Southern Regional Planning Panel Supplementary Report |

Panel Reference	PPSSTH-311
DA No.	DA-2023/849
LGA	Wollongong City
Proposal	Multi-dwelling housing development comprising 236 dwellings and associated earthworks, road construction and delivery, civil and landscaping works, community facilities (Stage 1) and use of up to five (5) dwellings for temporary exhibition homes
Property	Lot 197 Bong Bong Road Huntley
Applicant	Stockland Development Pty Ltd
Prior SRPP meeting	13 May 2025

Development Application DA-2023/849 was reported to the Southern Regional Planning Panel ('the Panel') on 13 May 2025. The Panel deferred the matter pending the submission of a supplementary report by Council. This supplementary report provides an overview of the information submitted by the applicant and Council's assessment to assist in the further consideration of the matters outlined in the Panel's Record of Deferral dated 21 May 2025.

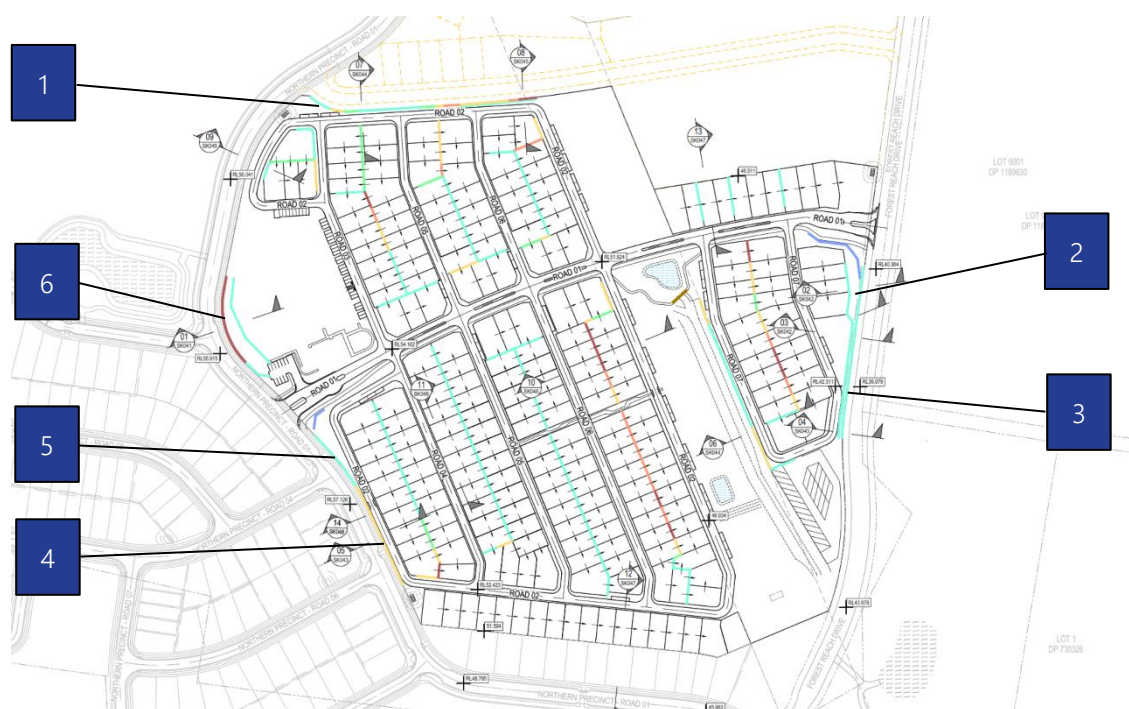
- The previous issue raised in relation to retaining walls up to 2m high at common lot boundaries has not been addressed. The extracts below show areas of retaining walls at 1.75-2.0m high as highlighted in yellow. These areas would potentially affect the amenity and solar access of the rear alfresco and clothesline areas of the proposed dwellings. This issue could be potentially improved with localised earthworks to reduce the heights of the lot boundary retaining walls at these locations.

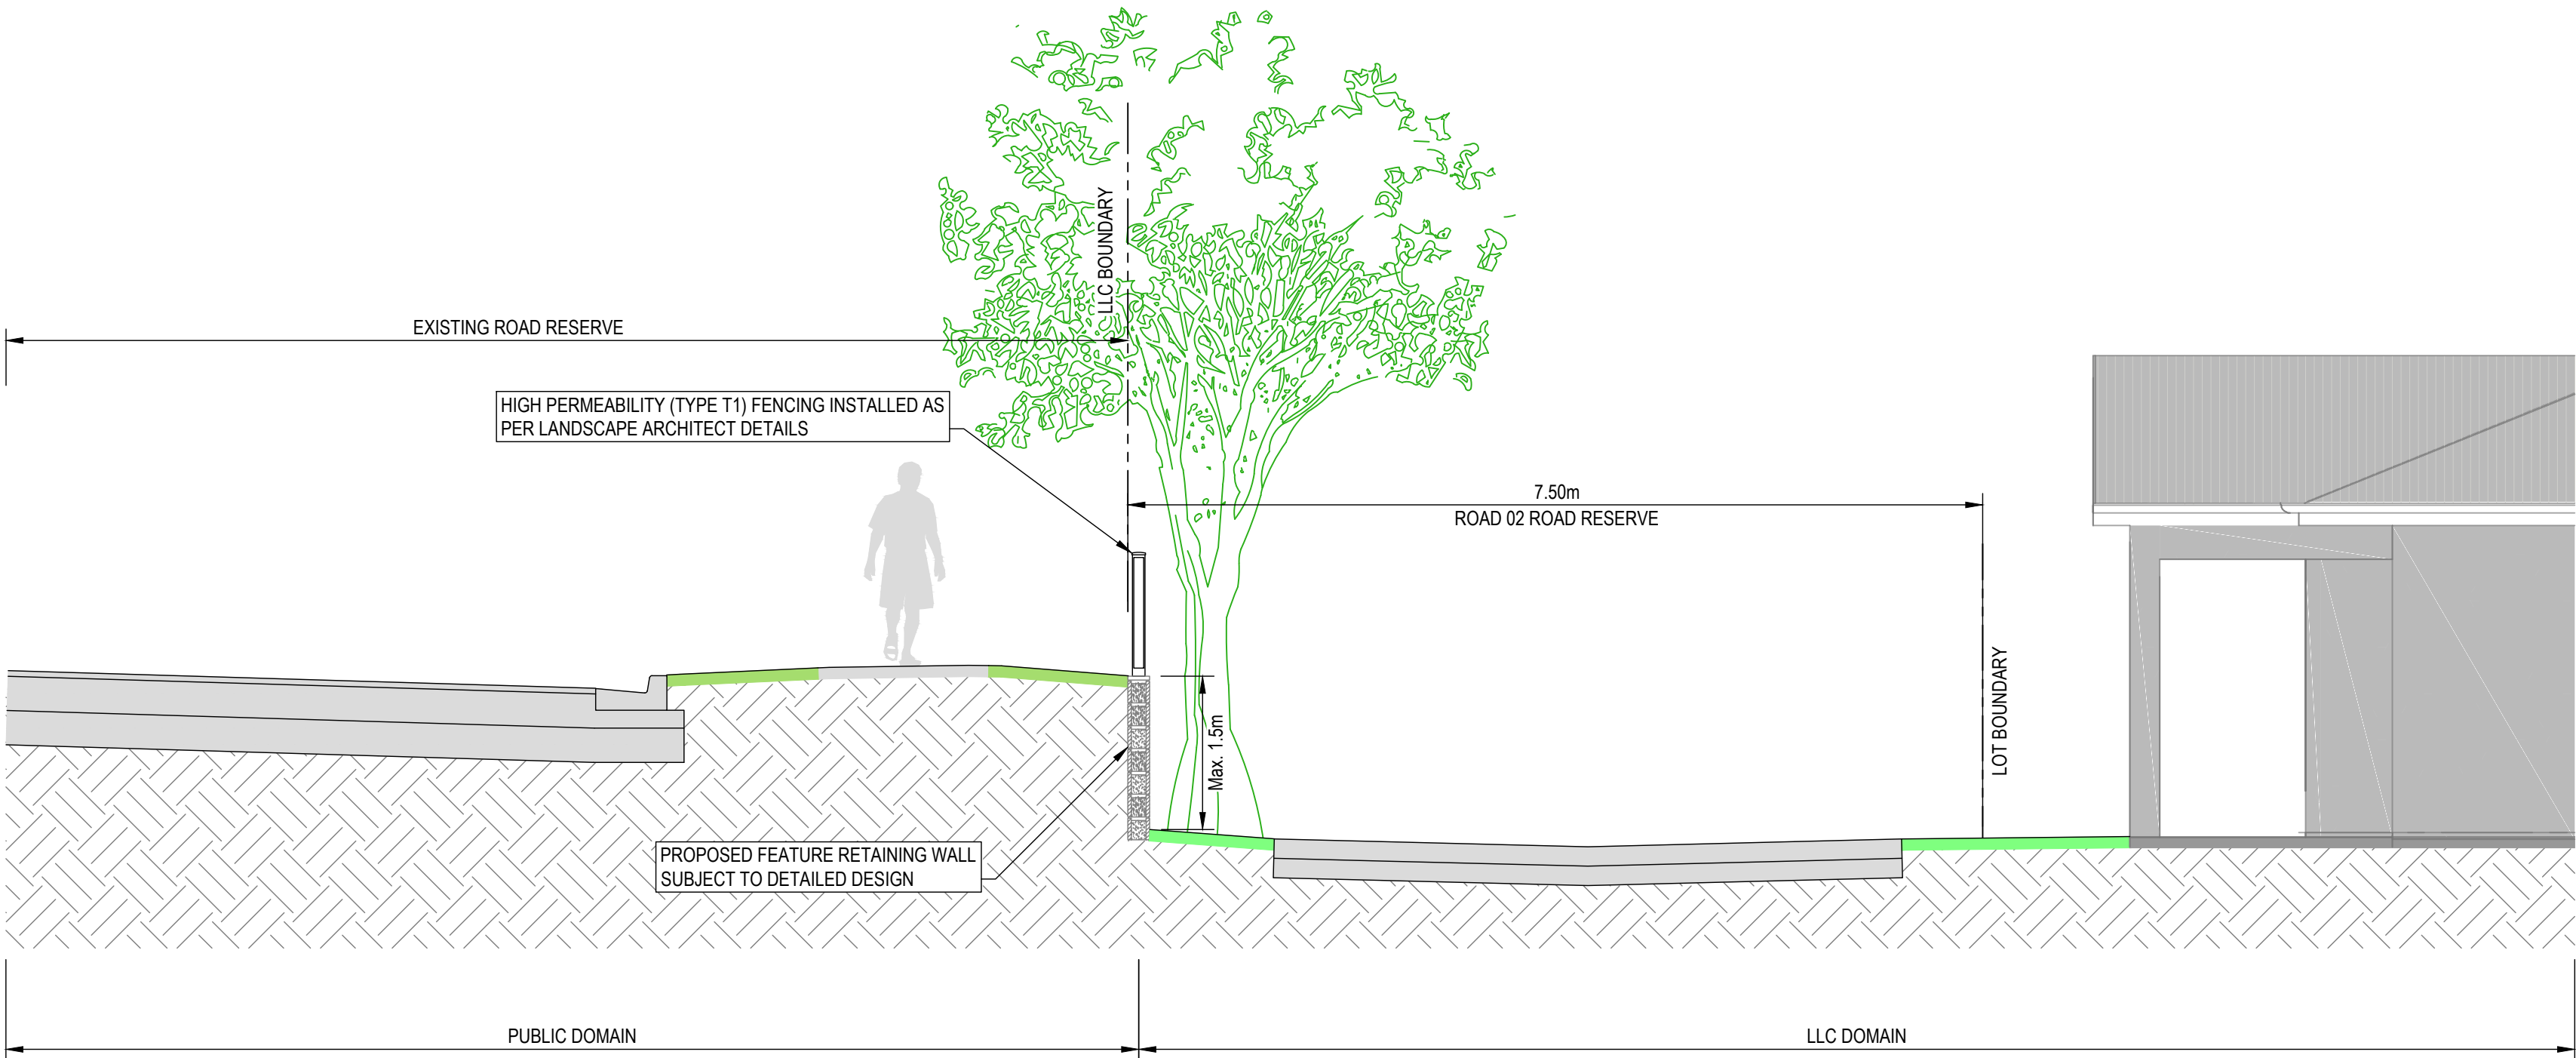
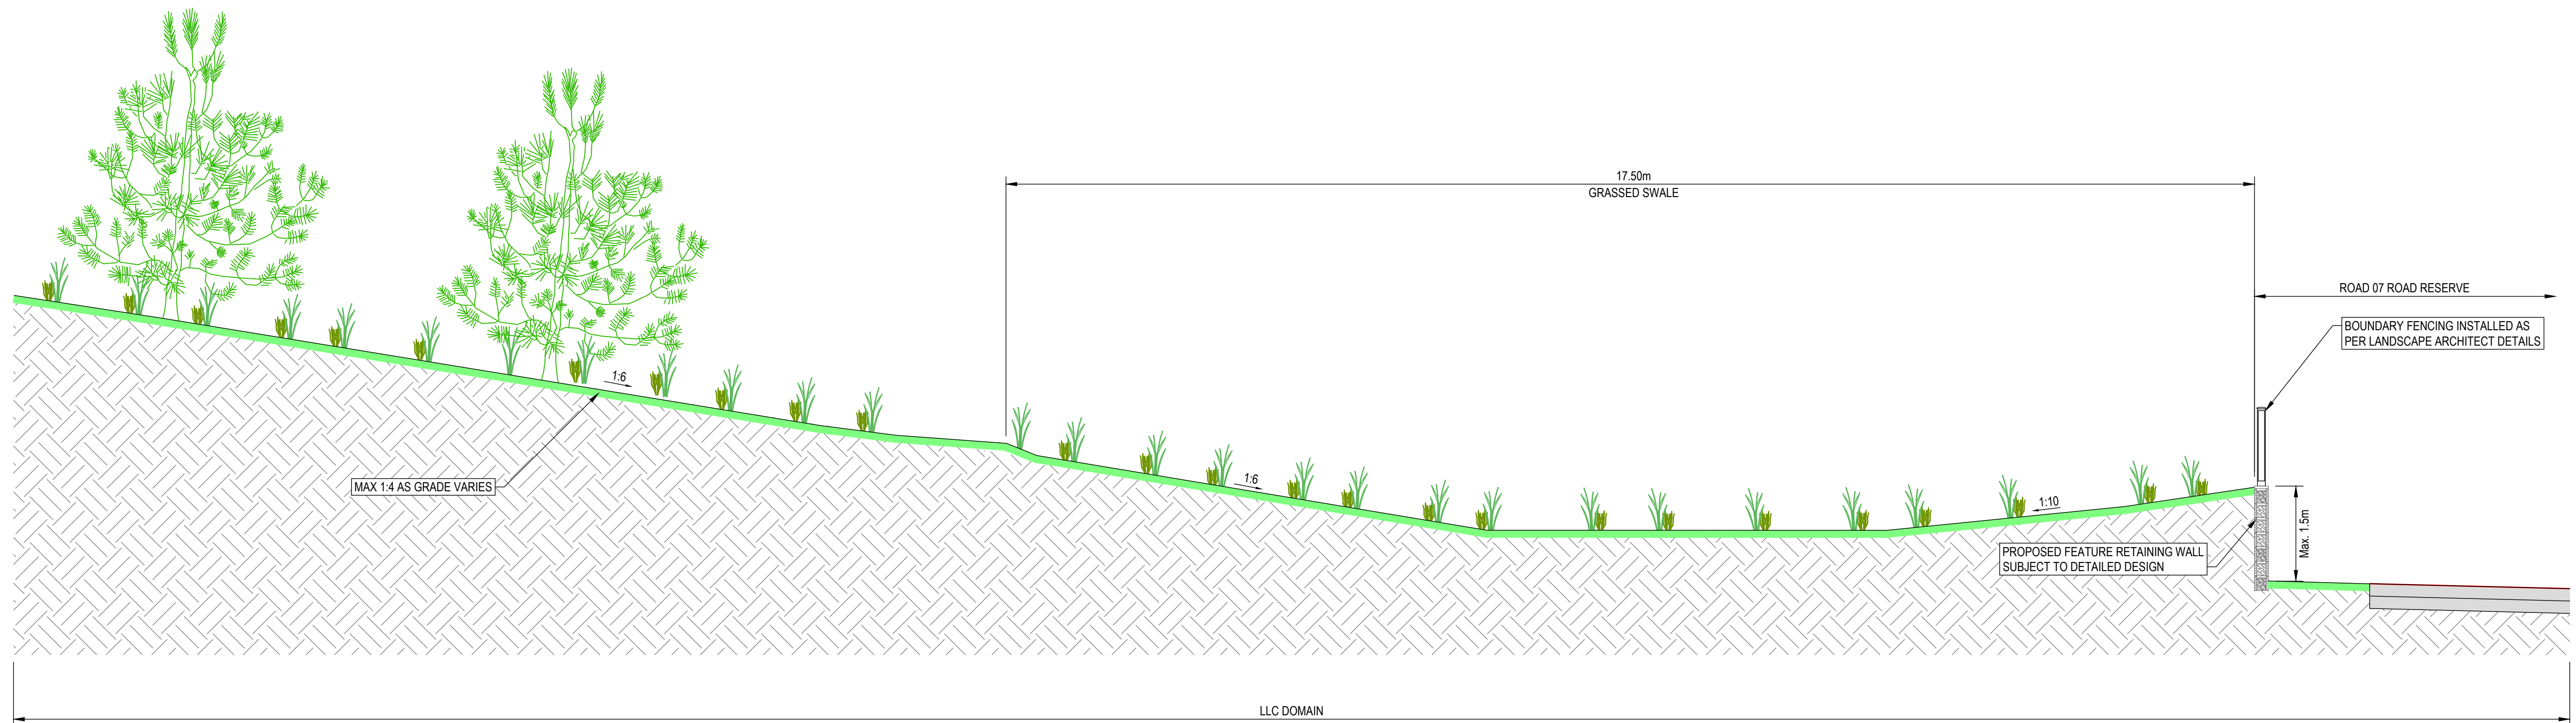
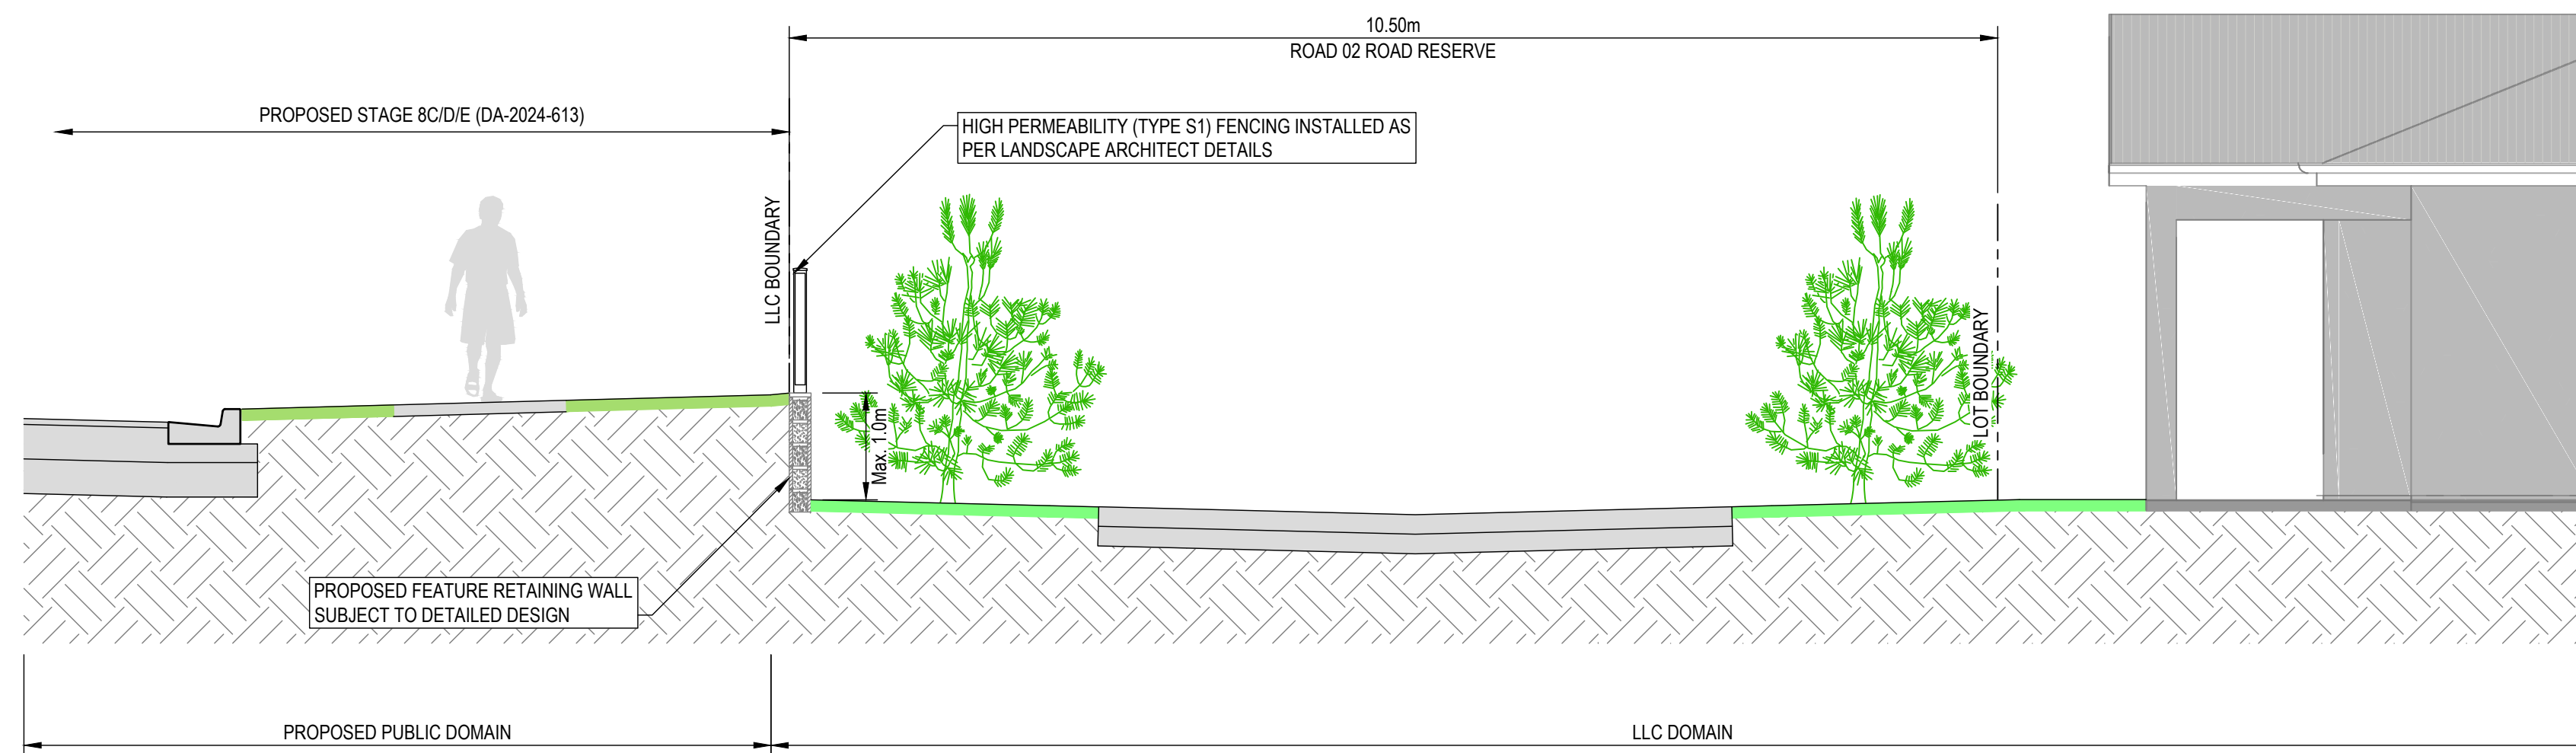
Location	Retaining wall detail	Applicant comment	Council comment
Northern boundary (Section 7 and 8 Sheets SK044 and SK045)	Interface with future public road, which will sit higher thus wall not visible from public domain Majority 1.25m in height or lower Eastern portion 1.5m and 2m with a short terraced 3m section due to transmission line easement interface	Minimal visual impact for future pedestrians and motorists as future road will sit higher than proposed multi dwelling housing development. Landscaping buffer at base of retaining wall will screen wall heights to minimise visual impacts internal to the development (note interface is secondary street façade for only 7 dwellings).	<i>Terracing of wall with landscaping provides a satisfactory design response to height differential between developments, subject to appropriate landscape provision.</i>
Eastern boundary (Section 2 Sheet SK042)	Interface with Forest Reach Drive. 1.5m high retaining wall originally proposed inside Site boundary. Now proposed to amend the design to utilise terraced retaining walls comprising of 1m high wall and 0.5m high wall at rear of dwellings with	Subject to condition, visual impact to Forest Reach Drive will be significantly reduced through reduced wall height and	<i>Terracing of wall with landscaping provides a satisfactory design response to height differential between development and Forest Reach</i>

The amended walls provide a suitable design response to minimising visual impacts from public areas and are capable of support, subject to appropriate conditioning regarding finishes, wall heights and the provision of screen landscaping if the development was to be supported.

1 LOT INTERFACE SECTION 01 - MAX 2.0 M RETAINING WALL SCENARIO
SCALE: 1 : 100

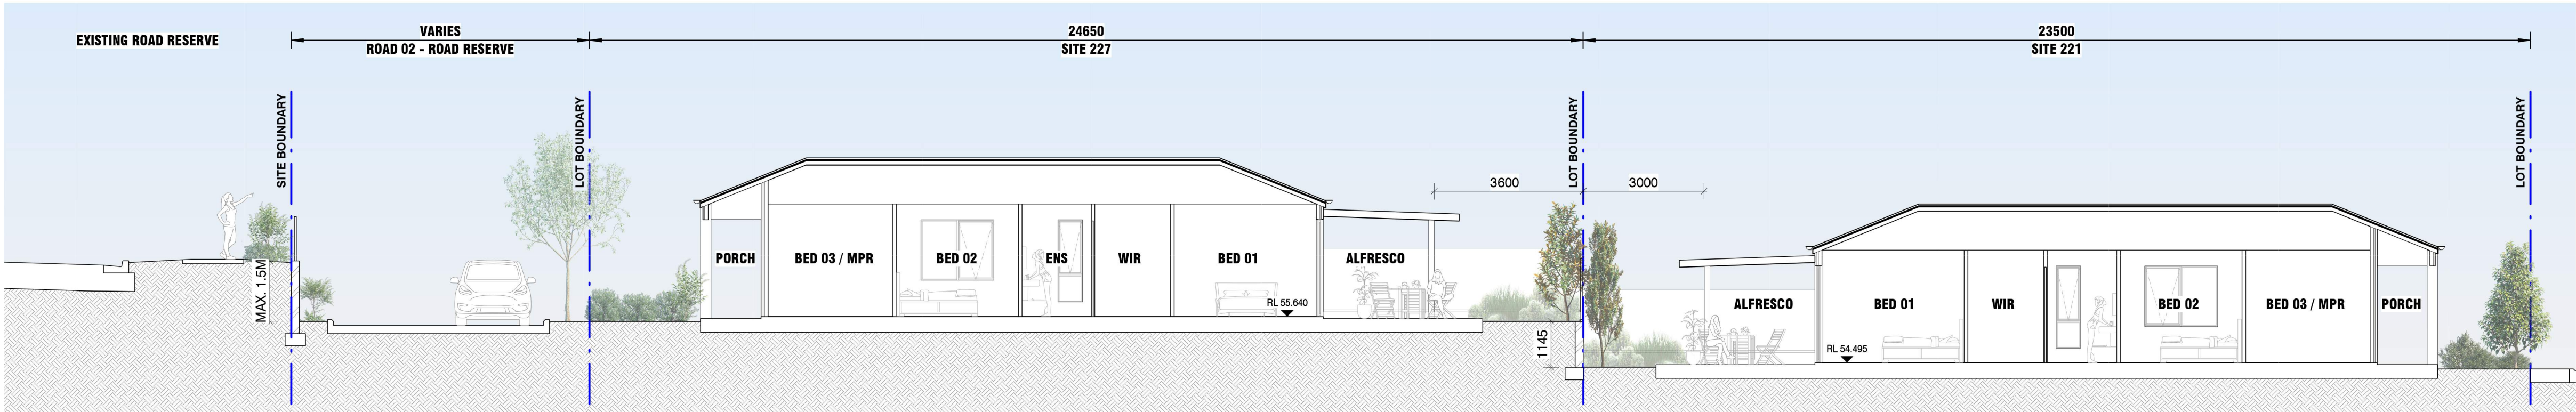
The retaining wall plan provided at **Attachment 2** shows numerous instances where interallotment retaining walls are 1.75m to 2m in height. An example of the impacts of proposed retaining walls with associated fencing can be seen around Sites 102 to 104 inclusive on the civil layout plans – these sites are identified as having a maximum 2 metre high rear retaining wall on the most recent Retaining Wall location plan (Site Typical Sections Layout Plan). A 1.8 metre high interallotment boundary fence, as proposed, placed on top of this wall would result in a 3.8 metre high “wall/fence” along the rear boundary, within 1.8 metres of the private open space of the lower dwelling, and does not appear to have been considered in the shadow diagrams.

Figure 2 DFE Impacts

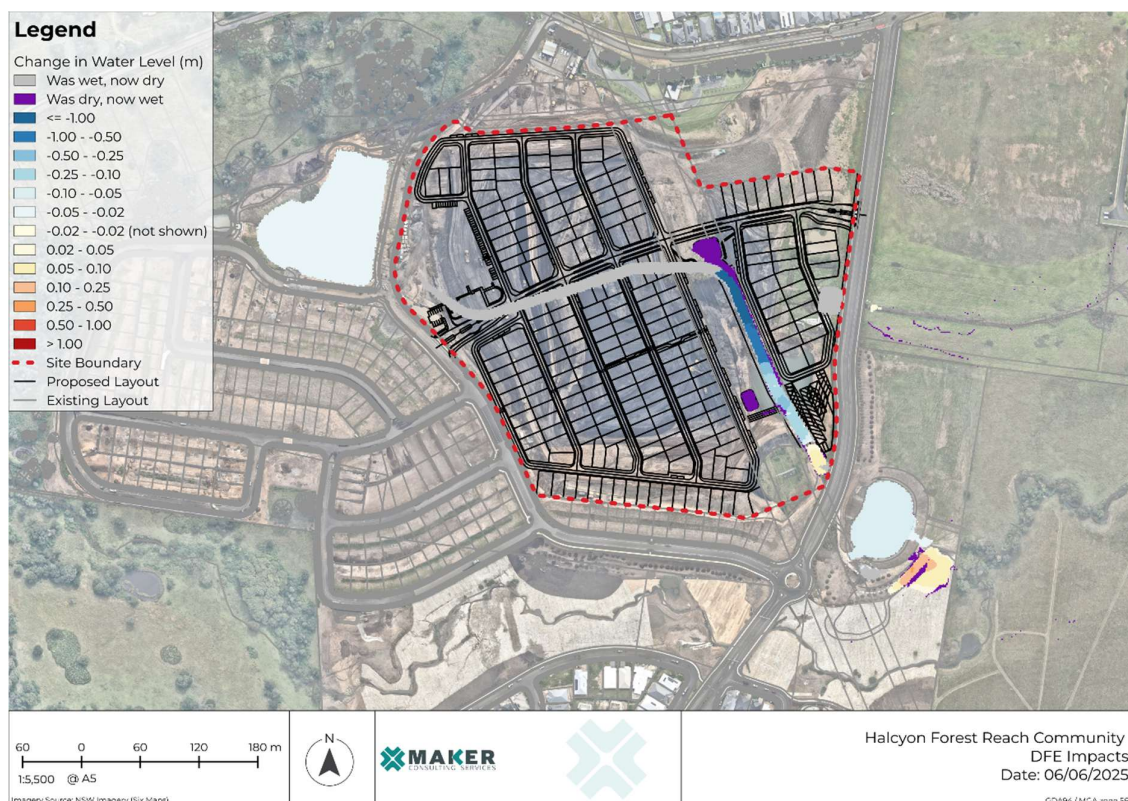
- *Figure 2 DFE impact map shows that there is an increase in flood levels downstream of the site that exceed the permissible impacts in Table 2 of Chapter E13. This does not demonstrate compliance with Chapter E13.*
3. ***The proposed development relies on external drainage and civil works that are part of separate approvals and have not yet been constructed. The flood modelling and stormwater design are based on assumptions about the final design levels and infrastructure outcomes of those external works.***
